Blair Creek Mitigation Project

Mitigation Plan – FINAL

Re: NCIRT Review and USACE Approval of the NCDMS Blair Creek Mitigation Site / Clay Co./
SAW-2018-00449/ NCDMS Project # 100047

Subject: Response to NCIRT Comments on Blair Creek Mitigation Plan Draft review
Blair Creek Mitigation Project, Clay County
USACE AID# SAW-2018-00449
Hiwassee River Basin: 06020002
DMS Project #100047, DEQ Contract #7415

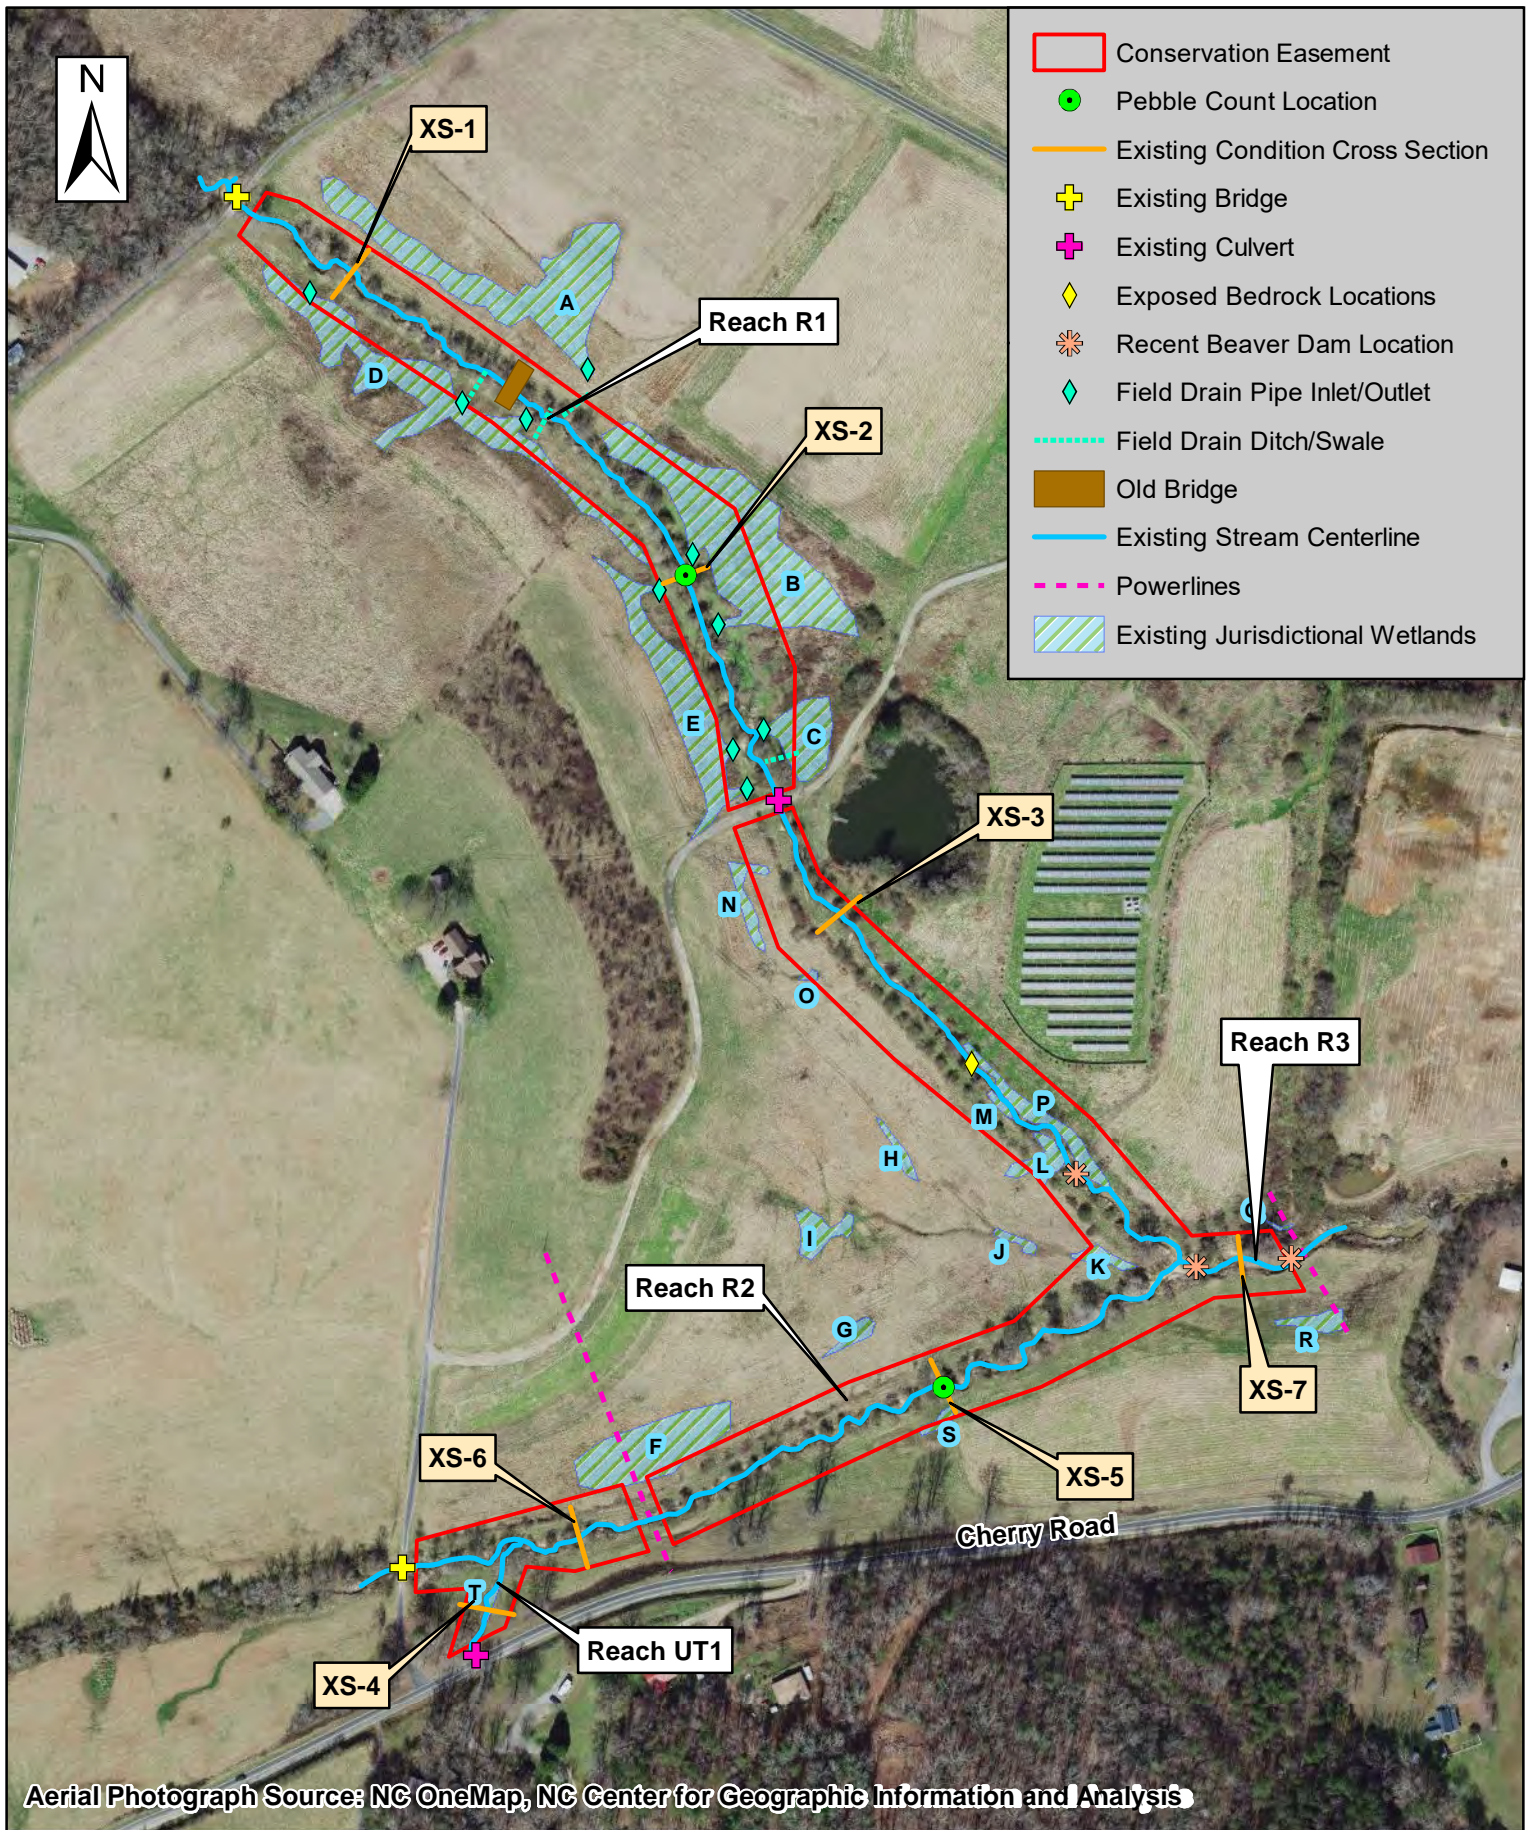
9. Figure 4 – What does the blue diamond indicate?

b. The existing field ditches/swales indicated on Figure 4 are not shown on the design sheets. Please provide call outs and/or shading to indicate proposed filling. Also, please callout of the removal of the old bridge.

Response: The light blue diamonds in Figure 4 represent field drain pipe inlets and outlets, as noted in the Legend. However, if they are not shown there, it might be an issue with the printed pdf in the hardcopy or with some aspect of the digital file transfer (zip-file problems), as happens from time to time. We will check and correct the issue if this is the case.

Response: The old bridge to be removed will be called out. Most of the low areas shown on Figure 4 as ditches/swales were already shown as filled or were no longer intercepting the channel since it is being moved. However, fill has been added to two additional low areas.

<p>North Carolina Division of Mitigation Services DMS Proj. No. 100047</p>	<p>1 inch = 300 feet</p>	<p>Figure 11 Proposed Monitoring Features Blair Creek Mitigation Project Clay County, NC</p>
--	--	--------------------------	---

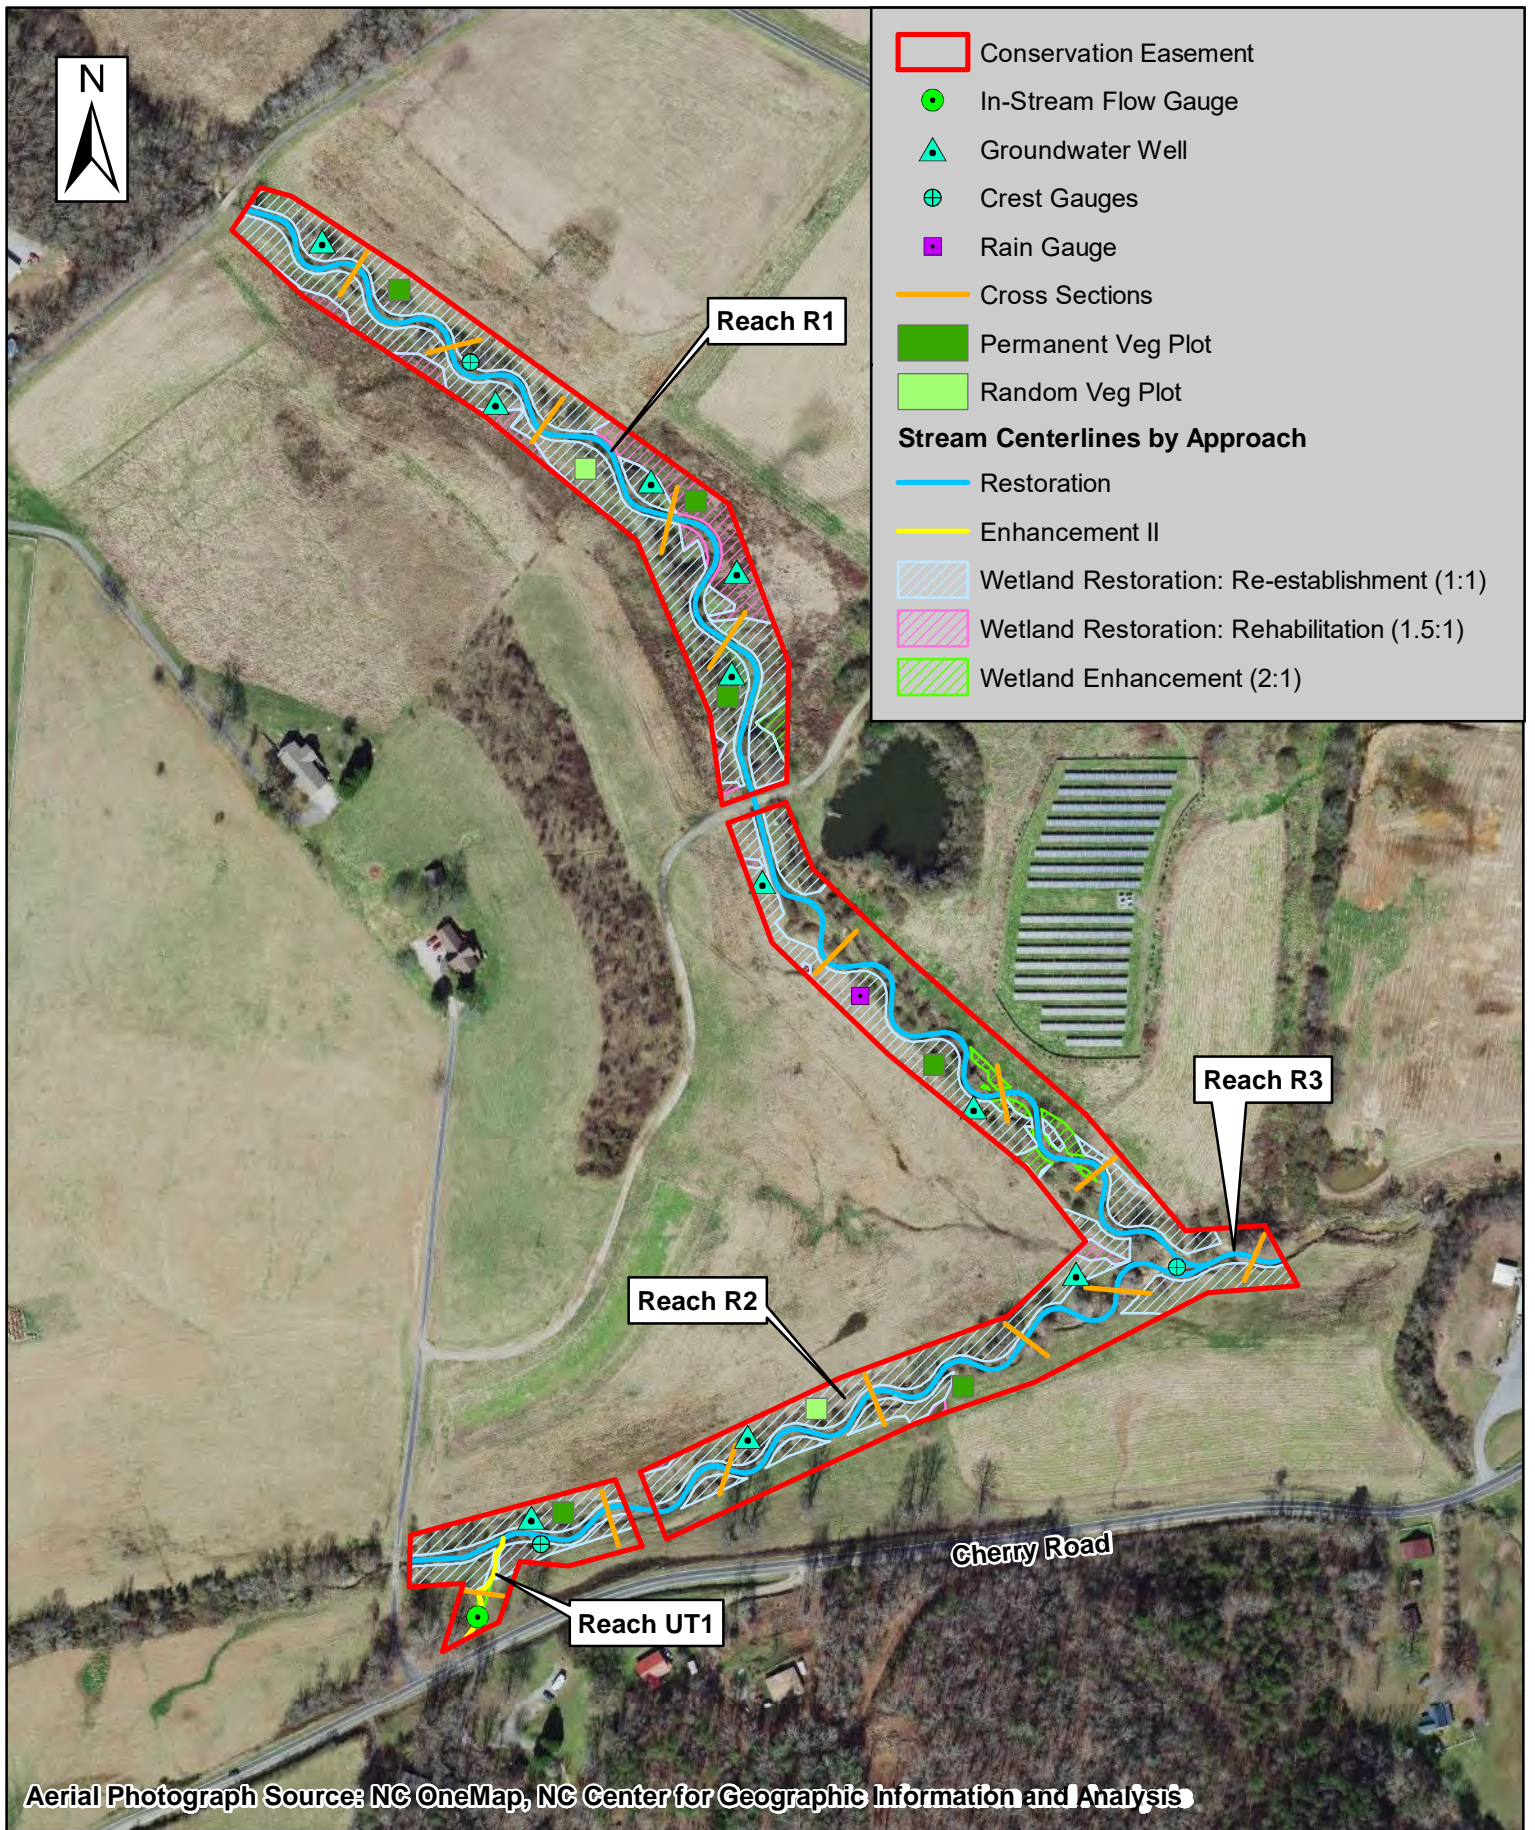
6. Figure 11: Please indicate the location of the rain gauge mentioned on page 7-4.

- Please provide DMS with proposed monitoring features displayed in Figure 11 (i.e. groundwater well, crest gauge, cross sections, etc).

Response: The proposed rain gauge location has been added to Figure 11.

R:\166274_Blair-Creek\Design\Plans\166274_PSH-06.dgn

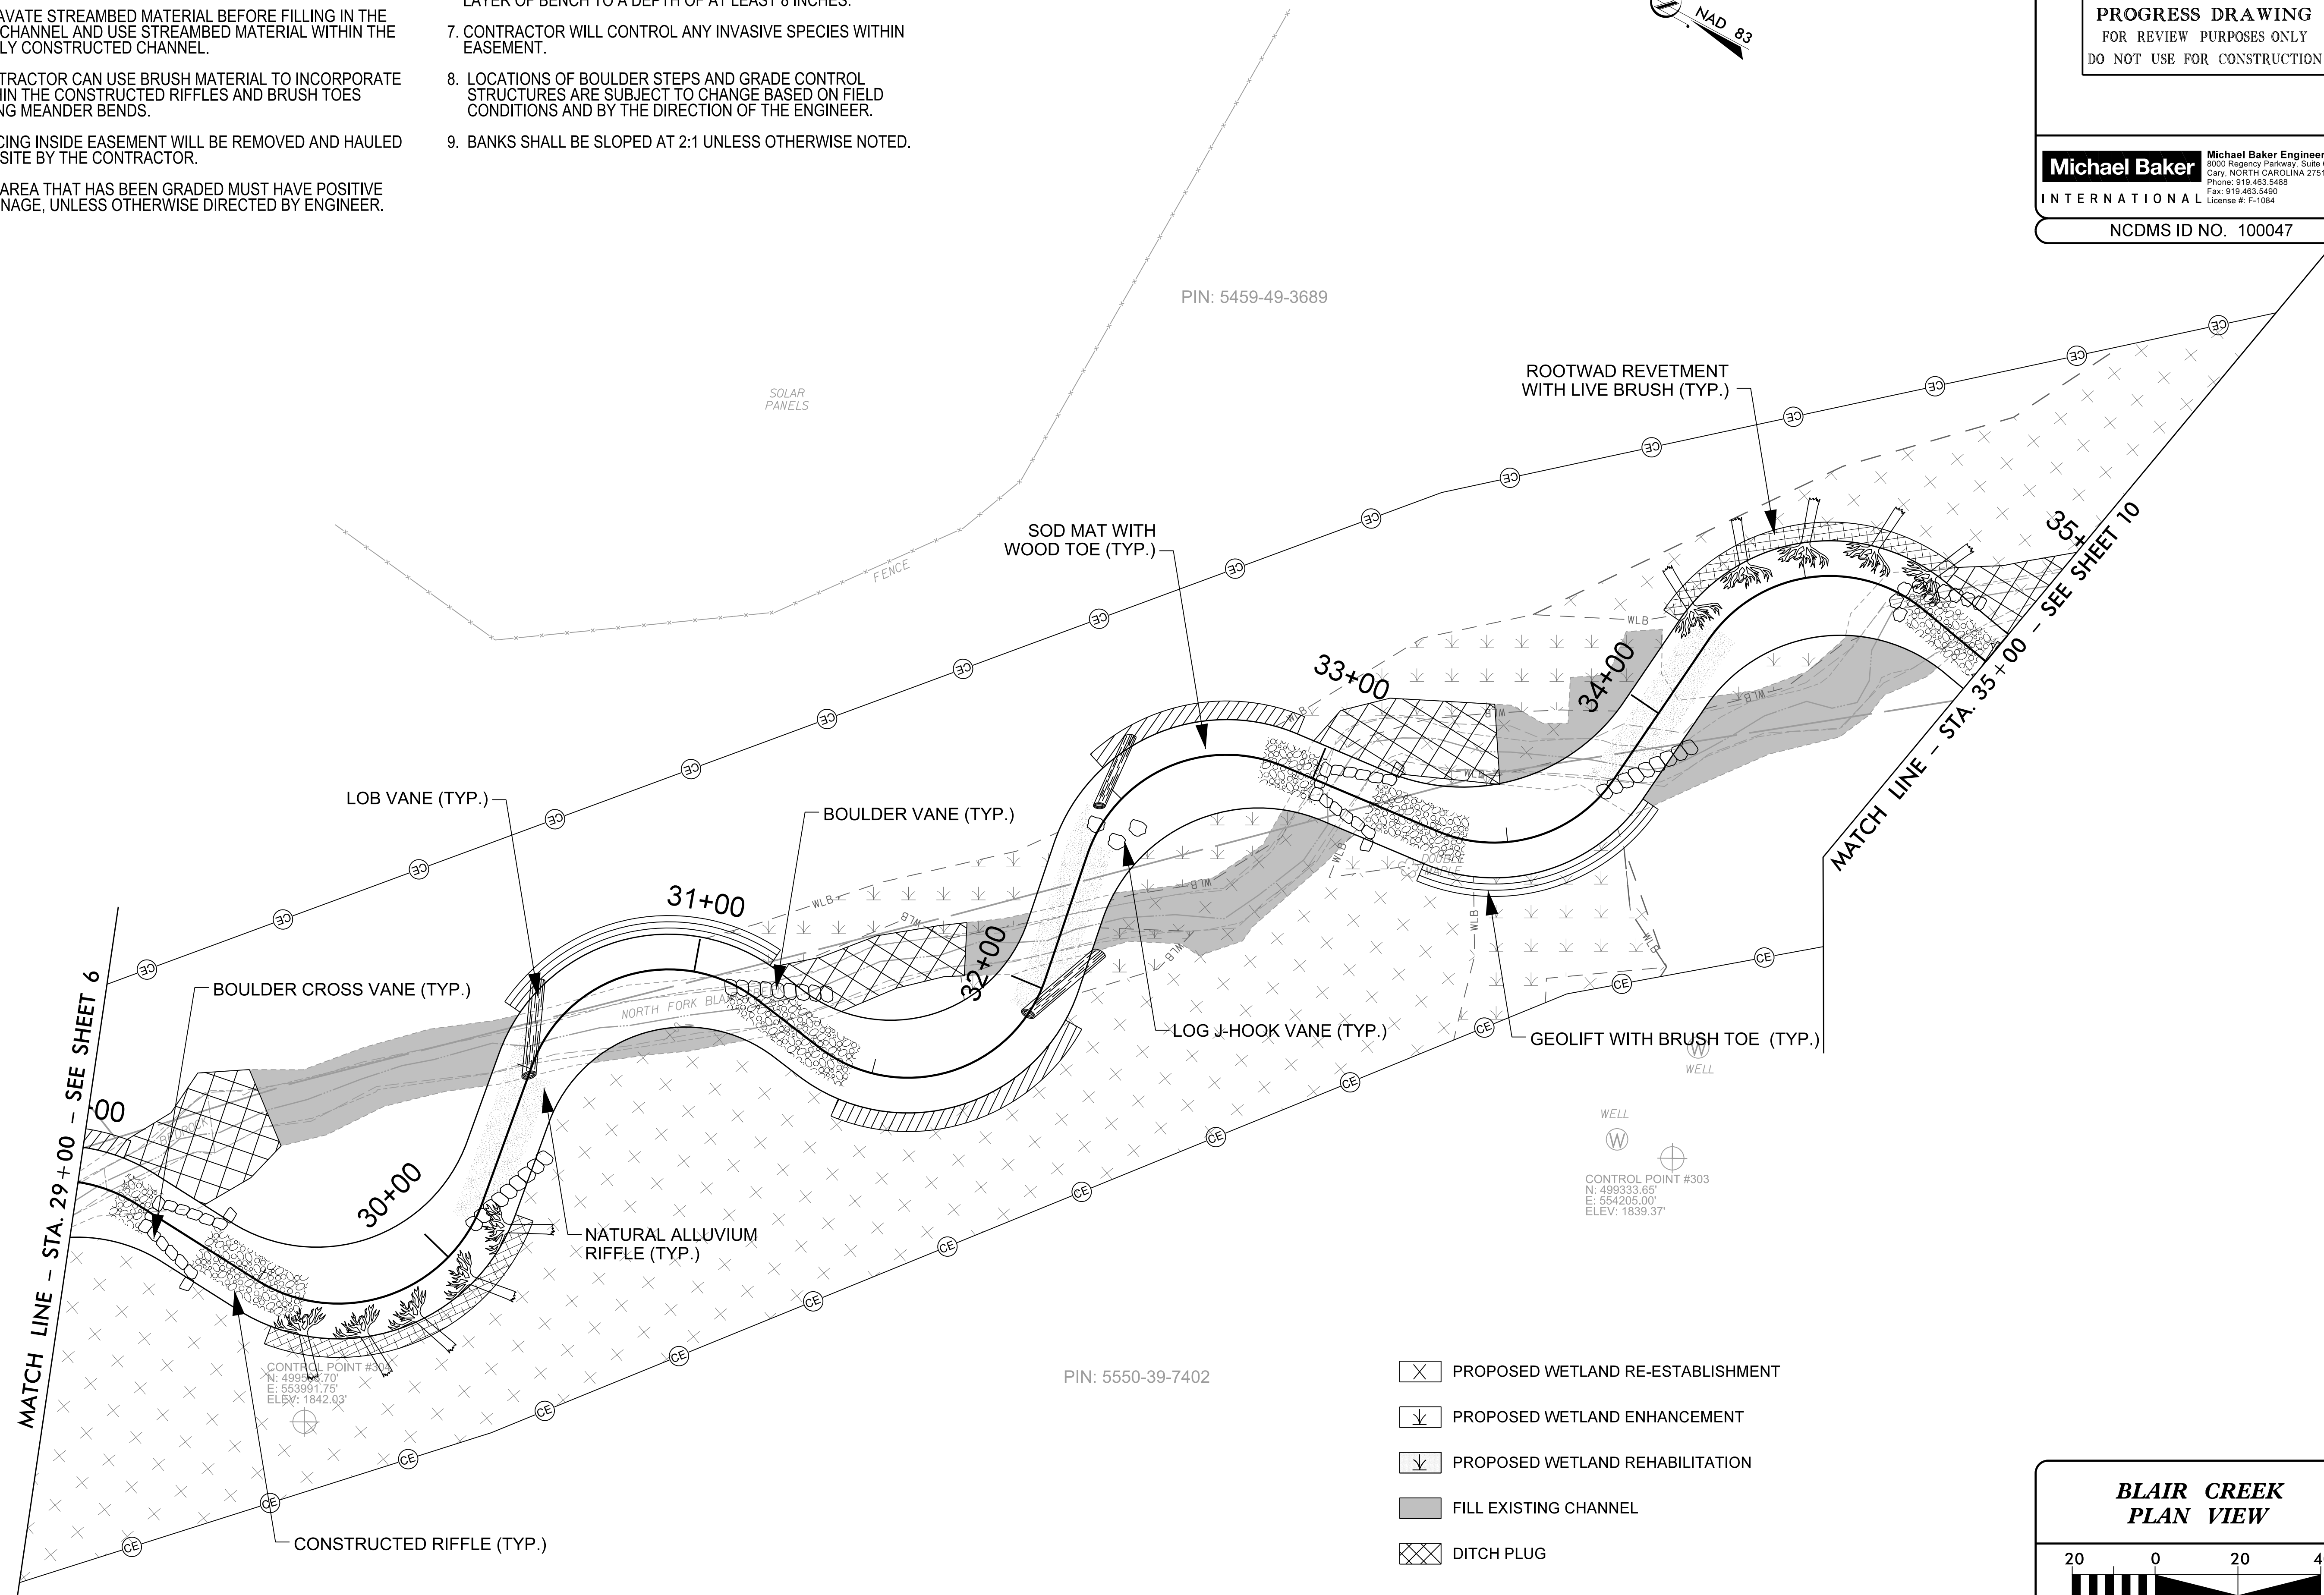
19. Sheet 6 – There appears to be a 6-inch PVC pipe entering the conservation easement (likely from the adjacent pond). Please confirm that pipe will be removed from the easement. Also, please indicate any proposed grading or treatment/structure for handling flow from the pond within the project area wetland and stream.
